ACTIONS
CITY OF CHARLOTTESVILLE
BOARD OF ARCHITECTURAL REVIEW
Regular Meeting
September 15, 2020 – 5:30 p.m.
Remote meeting via Zoom

**CITY OF CHARLOTTESVILLE
BOARD OF ARCHITECTURAL REVIEW
STAFF REPORT**

BAR 20-09-02

534 Park Street, Tax Parcel 530126000

2012 Google Streetview (From Farish)

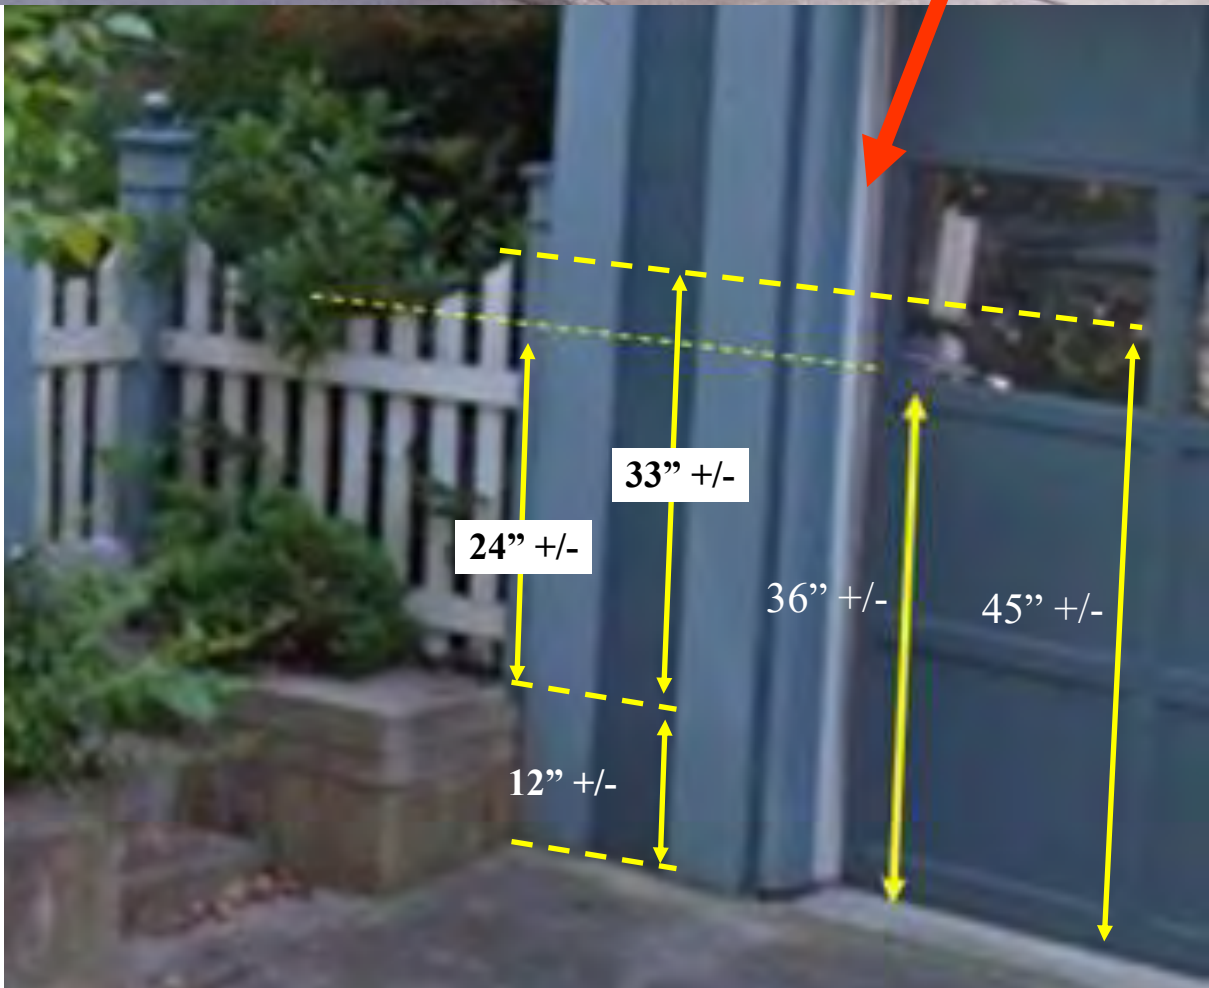
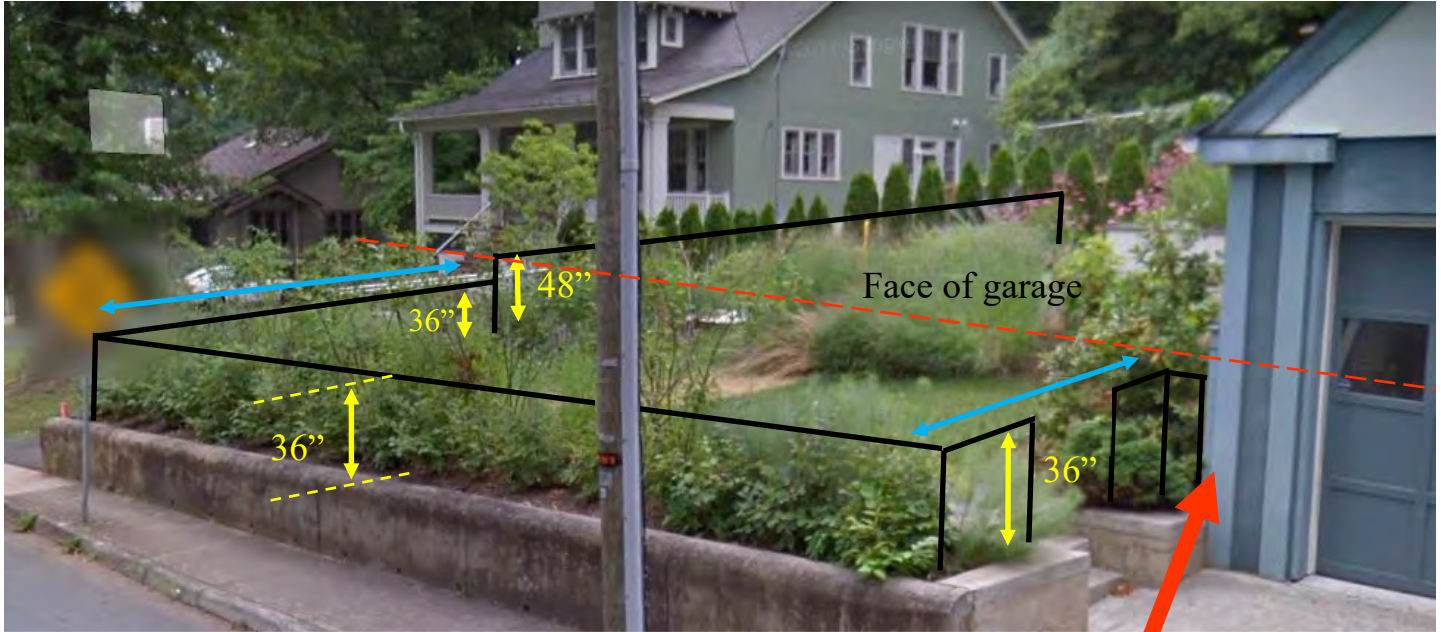
The rear yard is elevated with an approximately 18” high concrete wall. The proposed 36” tall fence results in a height that exceeds the recommended guidelines—fence should not exceed 4-ft in height from the sidewalk; however, until a few years ago, there was a 33” tall wood fence here (see photos) with posts approximately 48” in height. The proposed metal fence is of a similar height and less visible than the wood fence.

Staff recommends approval as submitted.
